N8262A-03

Modification Recommended Service Note

N8262A P-Series Modular Power Meter

Internal fan functionality and abnormal sound

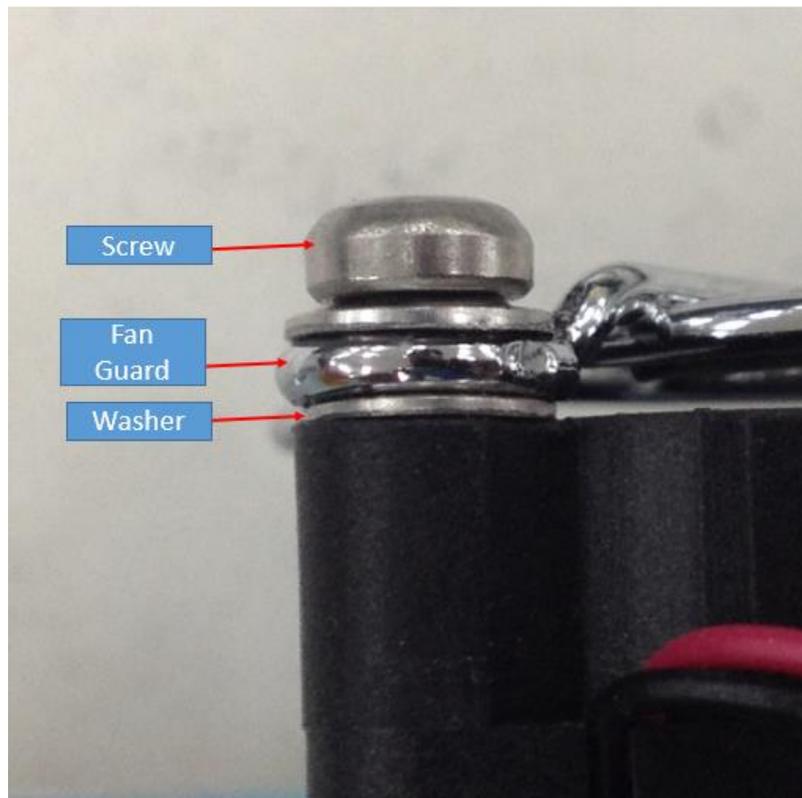
We have received reports of some N8262A P-Series Modular Power Meters had a malfunctioning internal fan and/or abnormal sound due to the fan.

- For the fan functionality, open the chassis and turn on the power on the unit. Visually inspect the fan.
 - If the fan has malfunctioned, replace it with (N8262-60104) Assy- fan.
- For abnormal sound originating from the fan.
 - If the noise was due to the fan blade rubbing against fan guard, added a washer (3050-2249) in between the fan and fan guard on each location to raise up the fan guard. This will prevent the fan blade from rubbing against fan guard.
